**Addendum No. 2
January 20, 2023**

Project: Baltic High School Addition
Baltic, South Dakota
Arch Project No. 2957

Architect: Architecture Incorporated

2.10

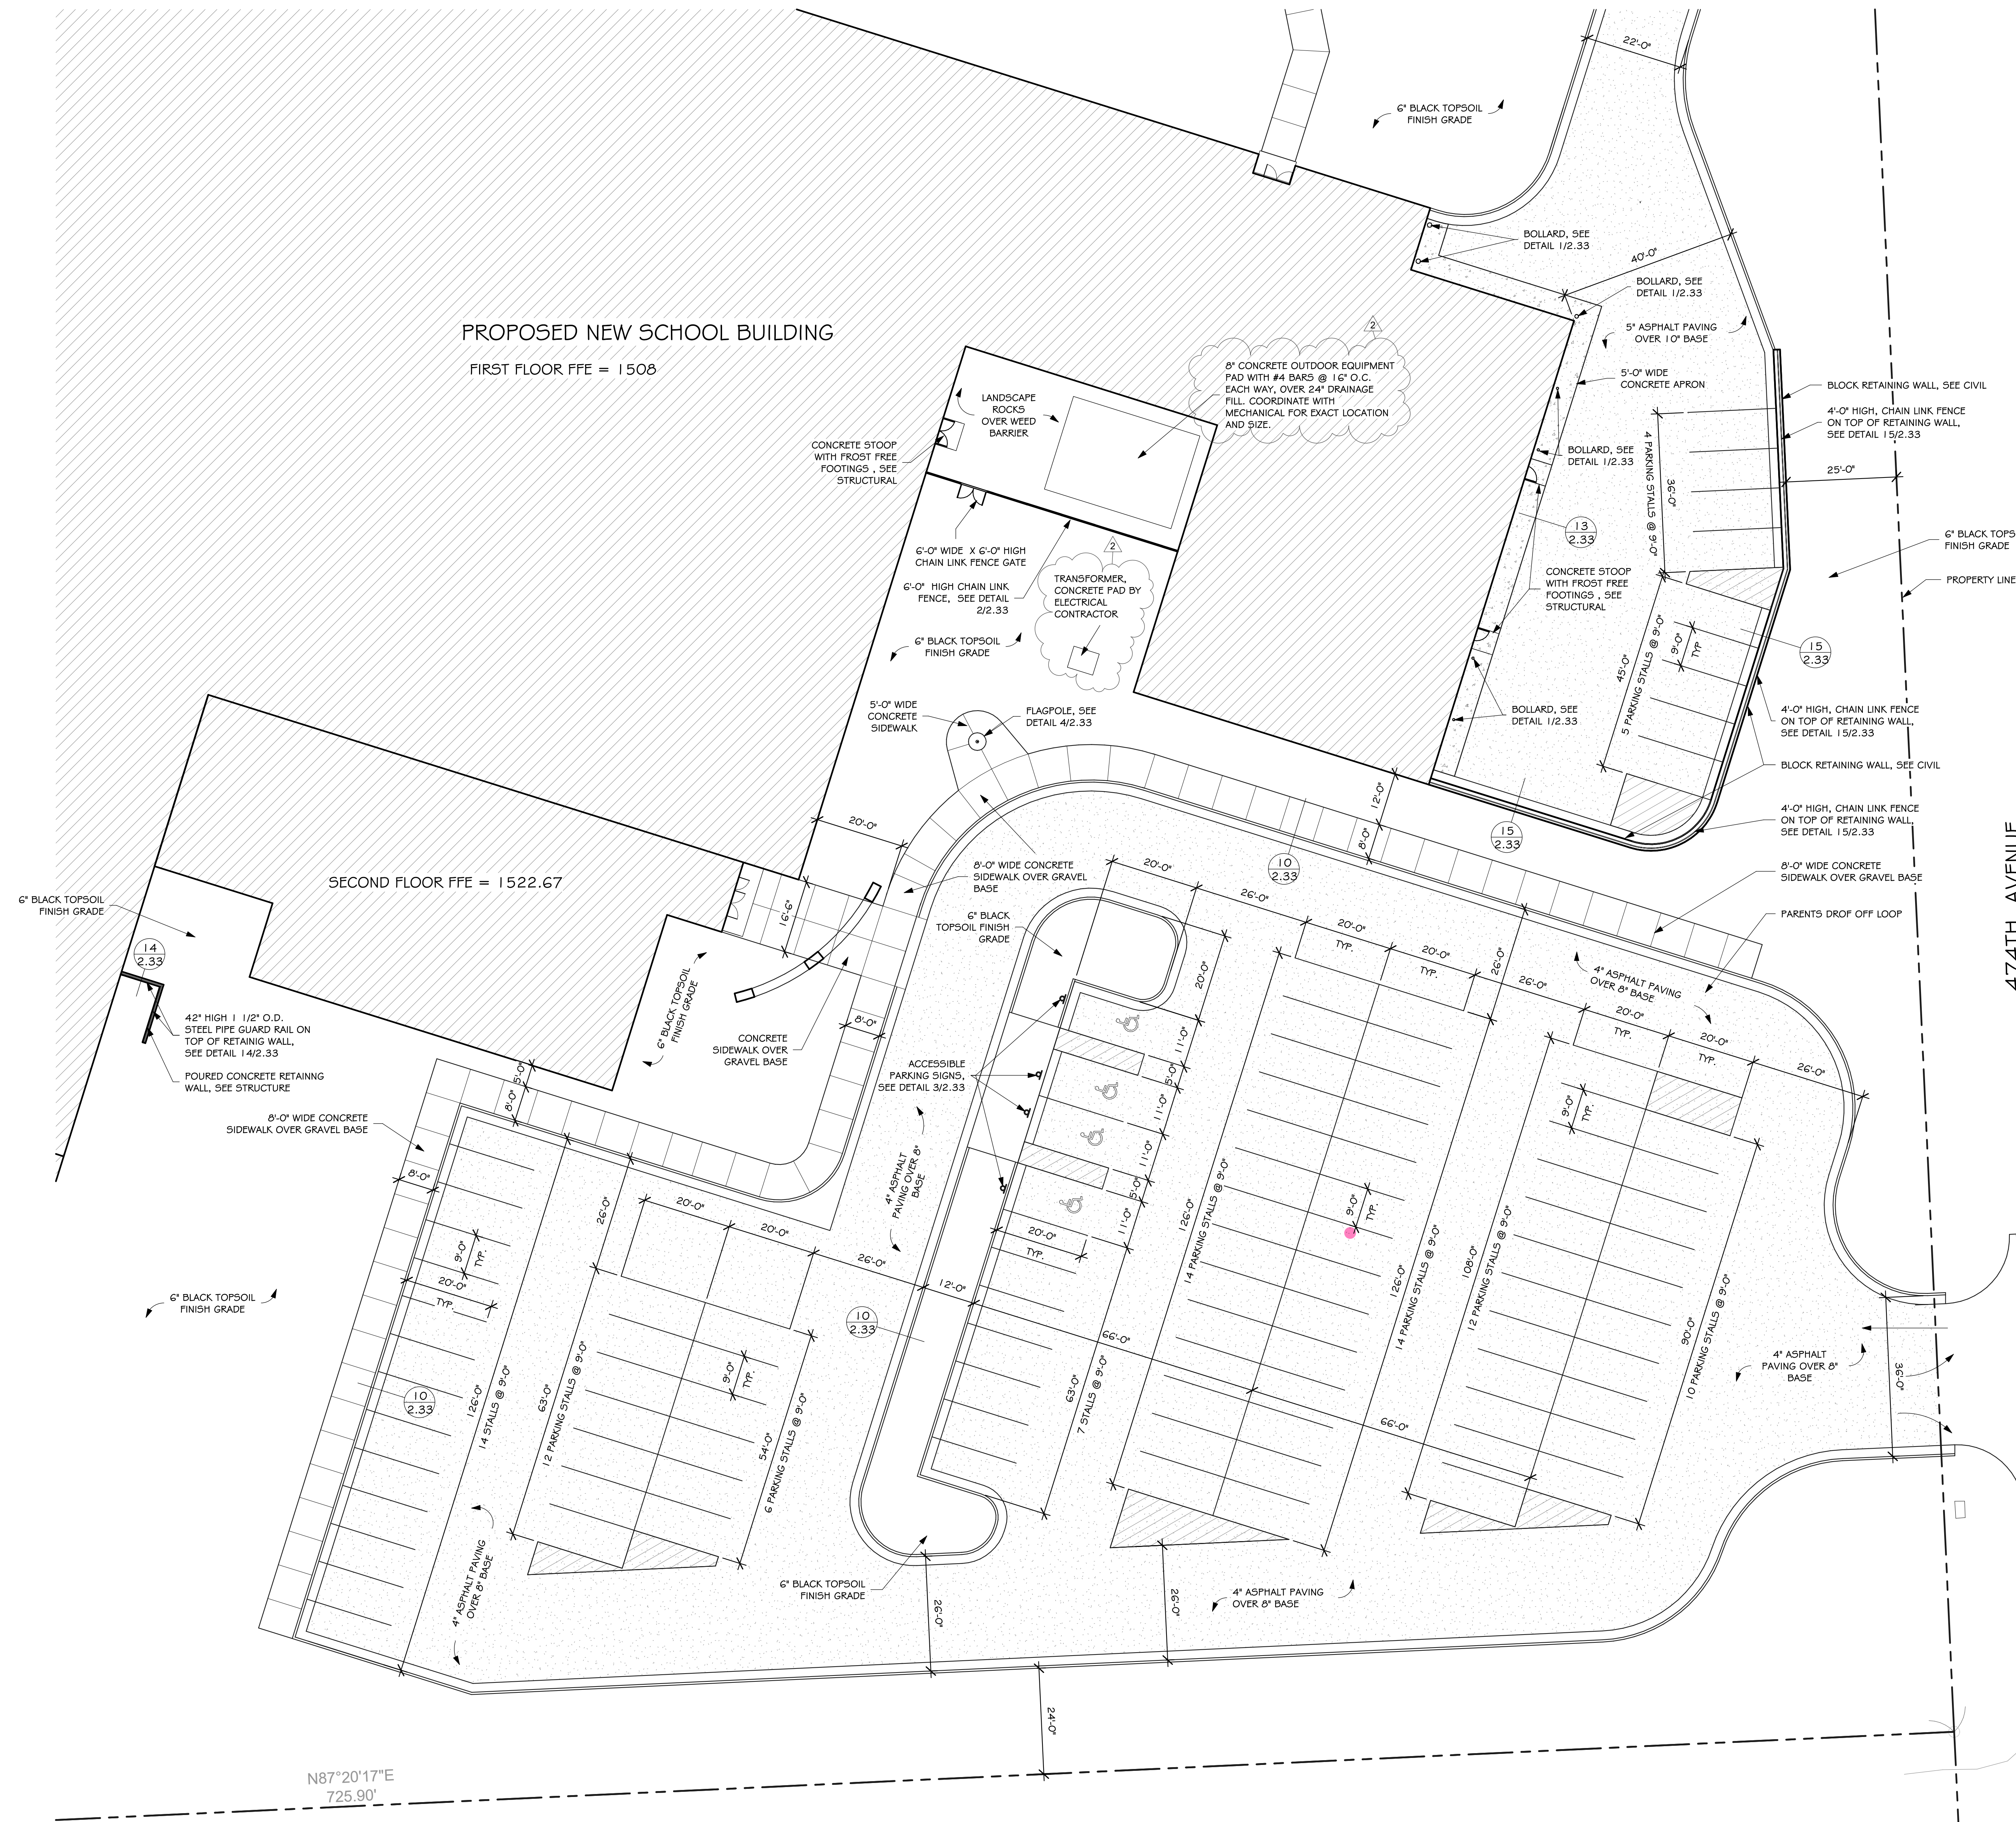
- a) Civil drawing Sheet 2.10 has been updated to include existing contours.
 - i) Reference revised civil drawing Sheet 2.10, revision dated 1-20-23, attached to the end of this addendum for additional information.

2.60

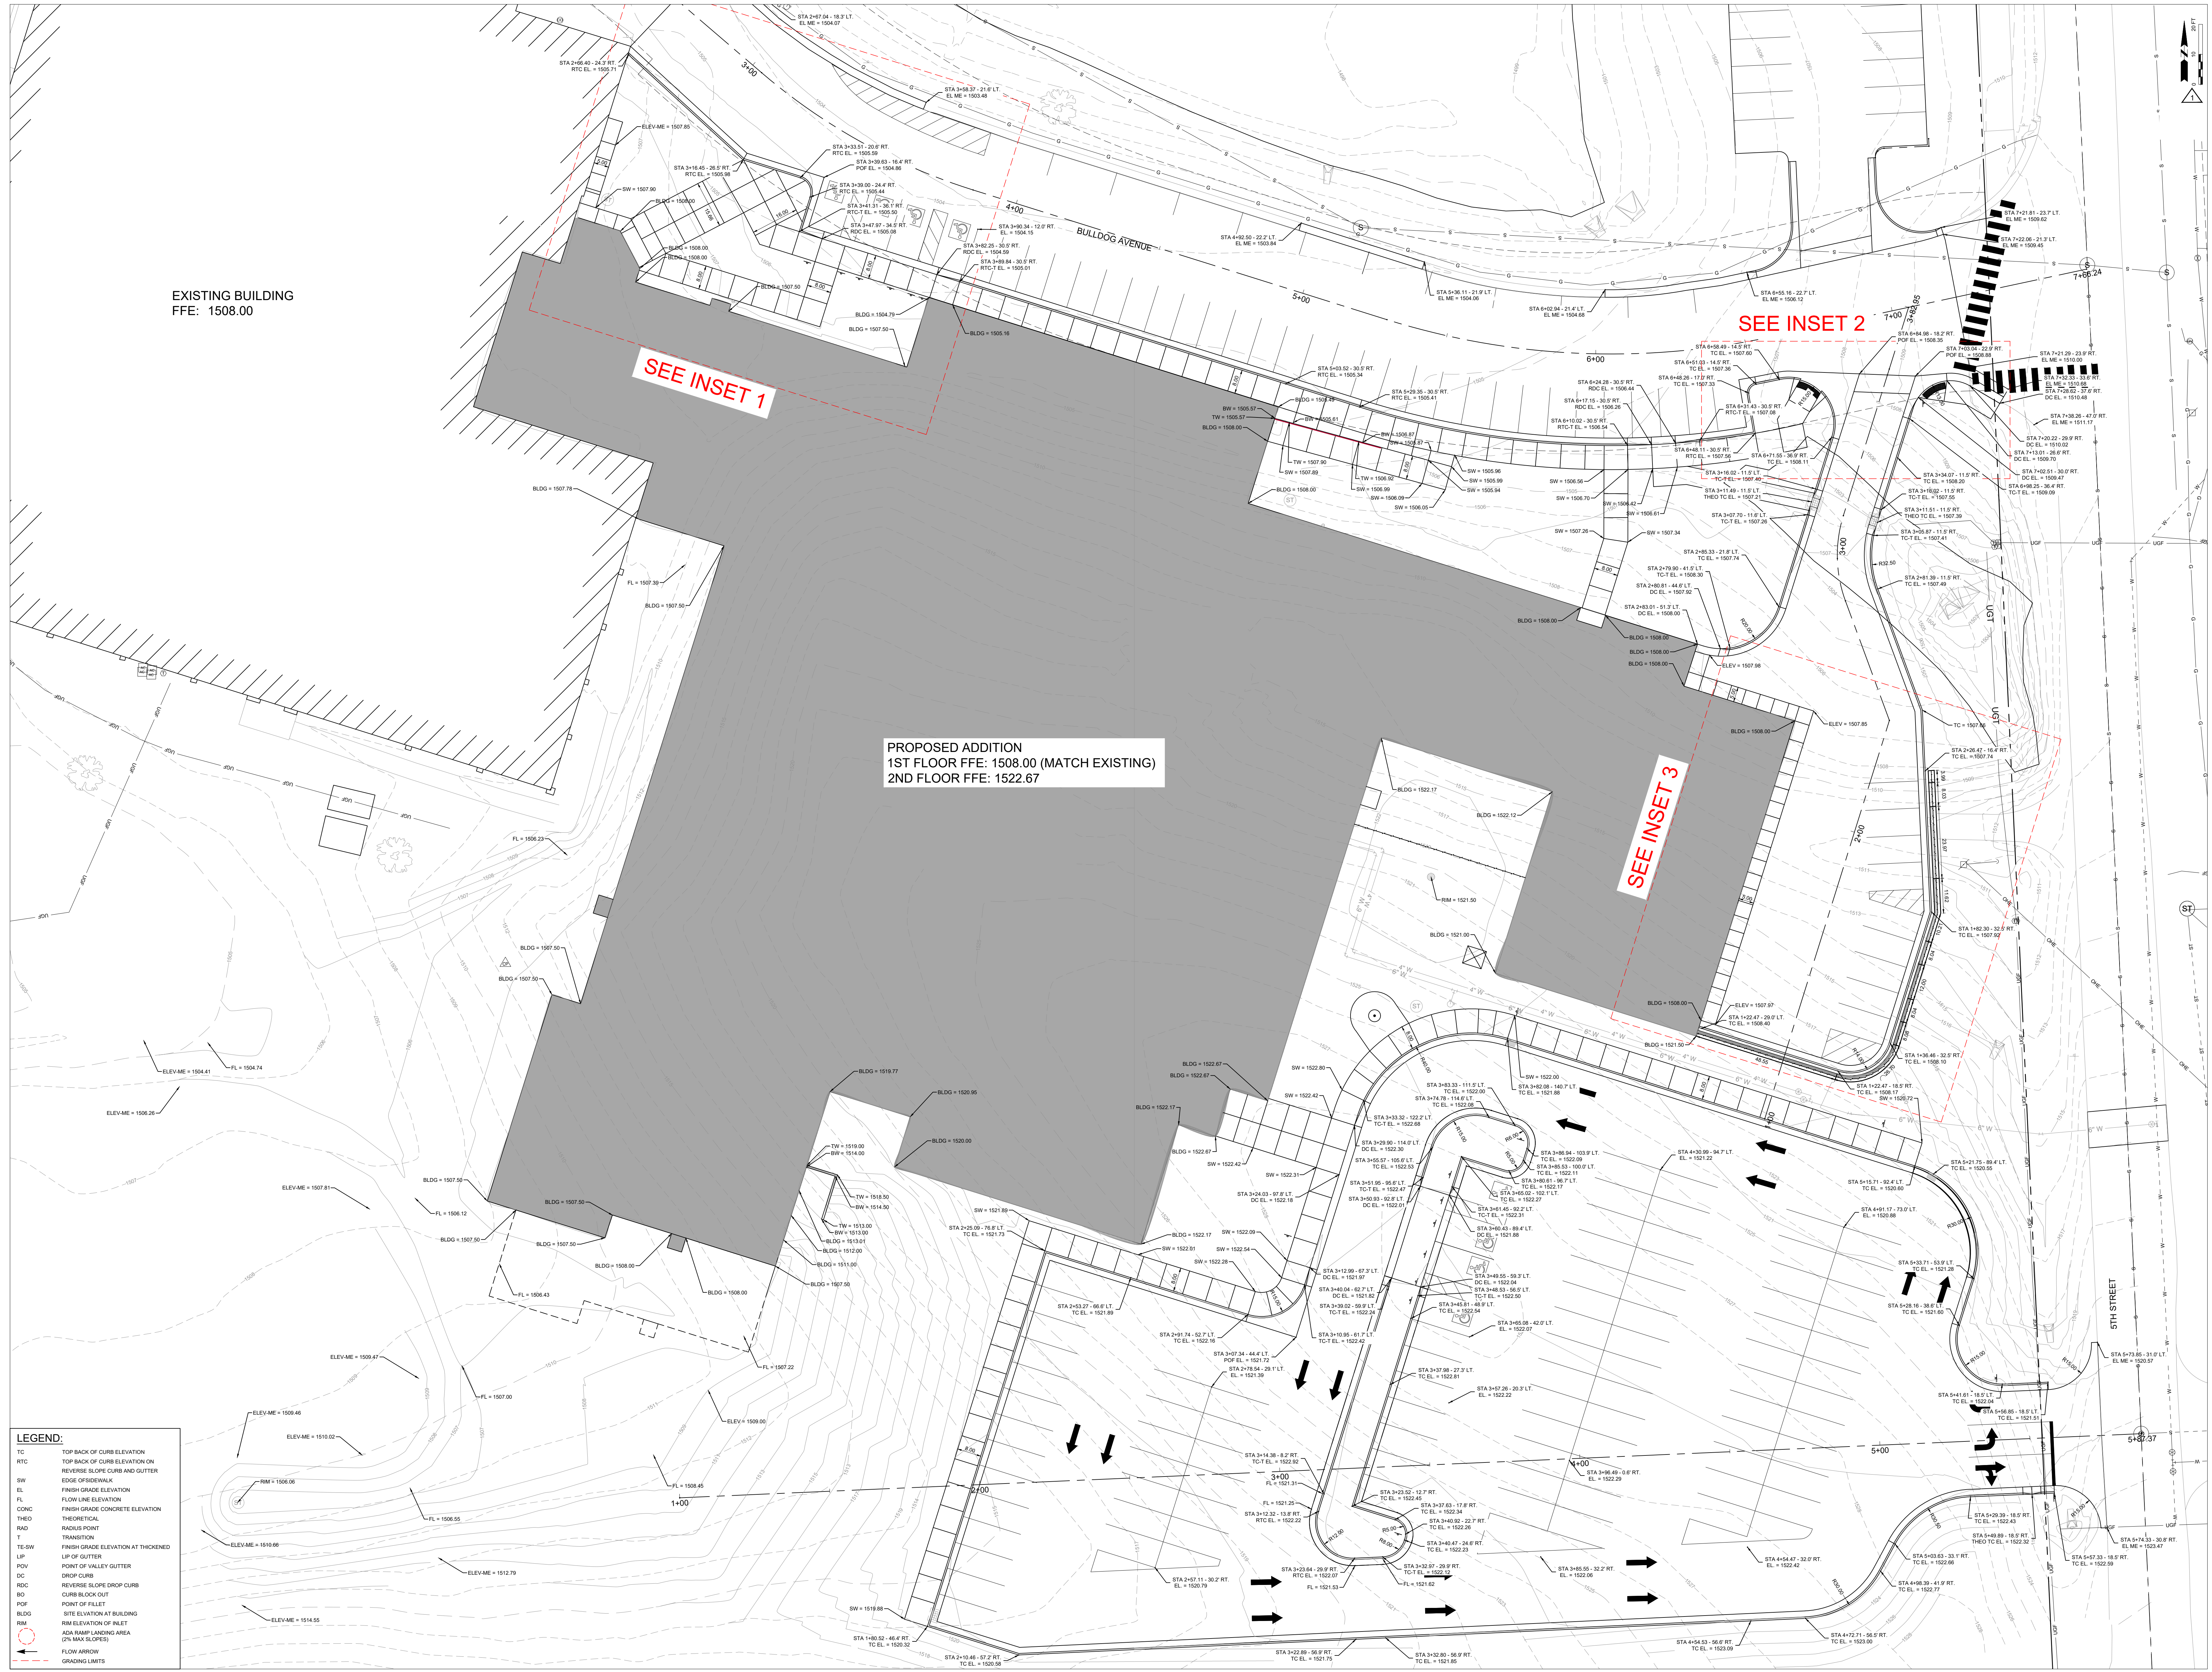
- a) Civil drawing Sheet 2.60 has been updated to include existing contours.
 - i) Reference revised civil drawing Sheet 2.60, revision dated 1-20-23, attached to the end of this addendum for additional information.
- b) Retaining Wall Clarifications:

- i) In general, the elevation of the top of the large block segmented retaining wall on the east side of the Project shall follow the finished grade elevations shown on the drawings.
- ii) For bidding purposes, the T.O. Wall elevation at the SE corner of WOOD H110 shall be assumed to be roughly 1522.00.
- iii) The bold lines shown along the length of the retaining wall on Sheet 2.60 shall represent segments of the retaining wall and the T.O. Wall elevations shall step accordingly at each location to closely follow finished grade. (typ)
- iv) The 48-inch high chain link fencing that is shown on top of this retaining wall assembly shall also step at these same locations.
